# UNITED STATES PATENT AND TRADEMARK OFFICE

APPLICATION NO.	FILING DATE	FIRST NAMED INVENTOR	ATTORNEY DOCKET NO.	CONFIRMATION NO.
10/708,423	03/02/2004	Mark O. Scates	10437.0081.NPUS01	2422

**Office Action Summary**

## **DETAILED ACTION**

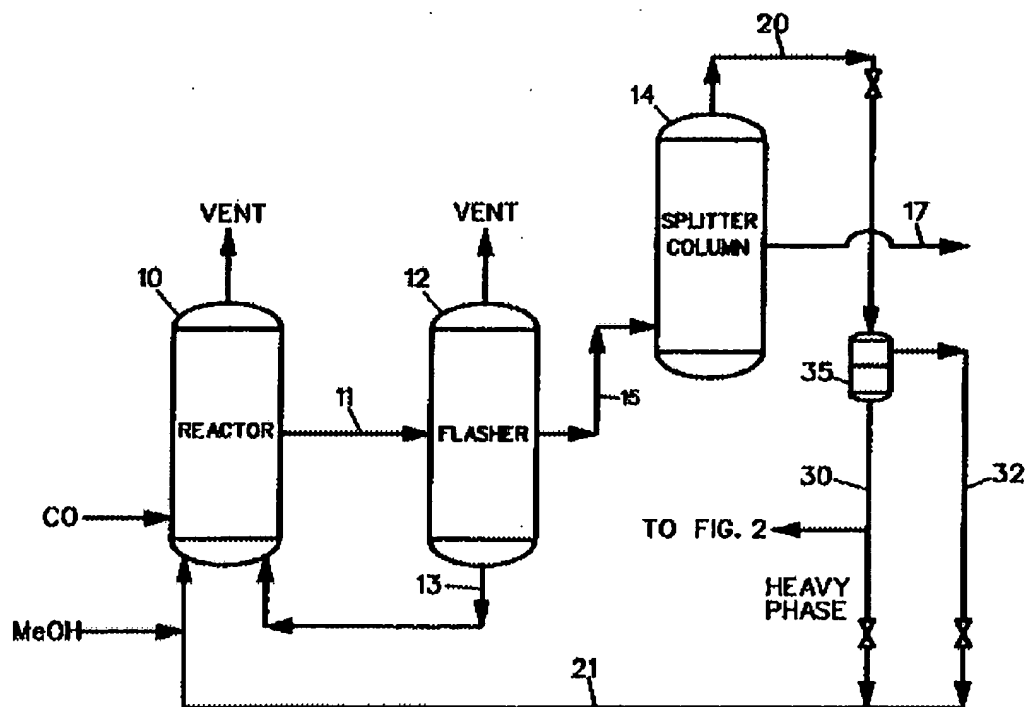
With regard to the above embodiments, Blay teaches a process with regard to the following figure:

Wherein liquid product is drawn off from carbonylation reactor 10 at a rate sufficient to maintain a constant level therein and is introduced to flasher 12 via line 11. In flasher 12 the catalyst solution is withdrawn as a base stream 13 (predominantly acetic acid containing the rhodium and the iodide salt along with lesser quantities of methyl acetate, methyl iodide, and water), while the overhead 15 of the flasher comprises largely the product acetic acid along with methyl iodide, methyl acetate, and water. Dissolved gases in stream 11 consisting of a portion of the carbon monoxide

along with gaseous by-products such as methane, hydrogen, and carbon dioxide exits the top of the splitter column overhead receiver.

The product acetic acid drawn from the side of methyl iodide-acetic acid splitter column 14 near the base (it can also be withdrawn as a base stream) is directed via line 17 for final purification such as to remove water as desired by methods which are obvious to those skilled in the art including, most preferably, distillation. The overhead 20 from methyl iodide-acetic acid splitter, comprising mainly methyl iodide and methyl acetate plus some water and acetic acid, is recycled via line 21 to the carbonylation reactor 10. When overhead 20 is condensed it typically splits into two liquid phases in decanter 35 if sufficient water is present. The heavy phase 30 is comprised mainly of methyl iodide plus some methyl acetate and acetic acid as well as the alkane and carbonyl impurities. The light phase 32 is comprised mainly of water and acetic acid plus some methyl acetate. The overhead heavy phase 30 from methyl iodide-acetic acid splitter is subject to treatment according to this invention or these streams can be combined with recycle products from further purification processes containing methyl iodide, methyl acetate, water, and other impurities to become recycle 21 which may also be subject to treatment according to this invention. See description bridging columns 5 and 6.

The difference between the rejected claims and the process disclosed by Blay is that Blay fails to teach adding dimethyl ether to the process in an amount effective to enhance separation of a first overhead to form a first and second liquid phases. It is for this proposition, however, that the examiner joins JP 250.
